Amendments to the Drawings

Application No.: 10/538,491
Art Unit 2809

Attorney Docket No. 0630-2337PUS1
Reply to Office Action dated May 10, 2007
Page 18

FIG. 1

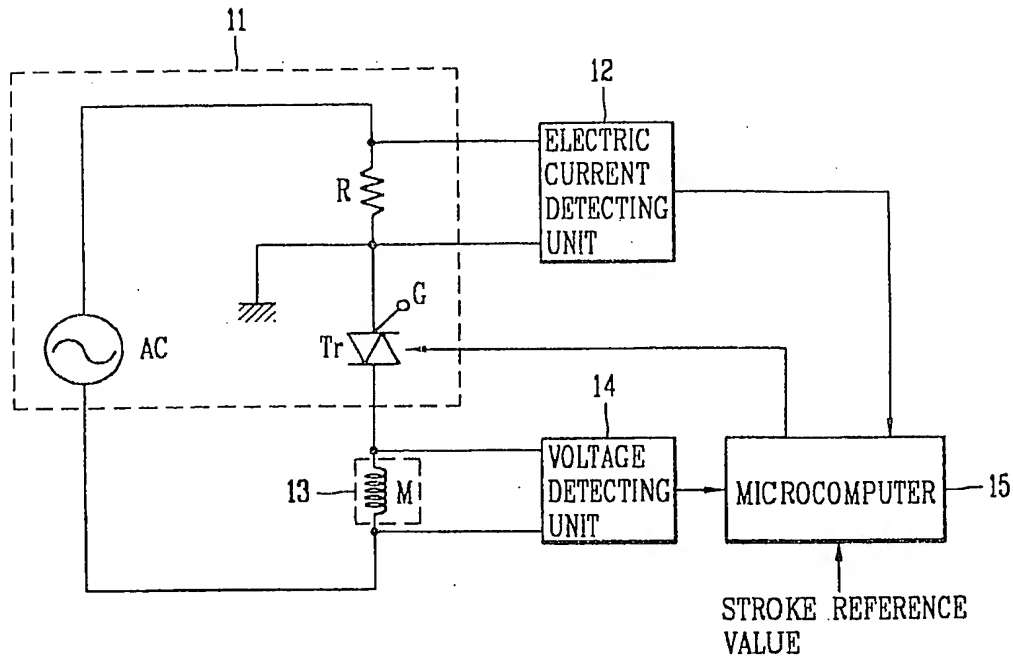
The Examiner has objected to the drawings because a legend such as "Prior Art" is not found in Fig. 1, and Steps S17 and S18 are identical in Fig. 3, whereas they are different in the specification. In order to overcome this objection, Applicants are concurrently submitting corrected drawing Figs. 1 and 3, which address each of the deficiencies pointed out by the Examiner. Applicants are amending Fig. 1 to include the legend "Conventional Art," which is the terminology used in Applicants' specification, for example, on page 2, lines 14-16.

Fig. 1 has been amended to add the legend "CONVENTIONAL ART," and Fig. 3 has been amended by changing "OPERATING A MOTOR IN THE POWER MODE" in step S18 to read - - OPERATING THE COMPRESSOR IN THE FULL MODE - -.
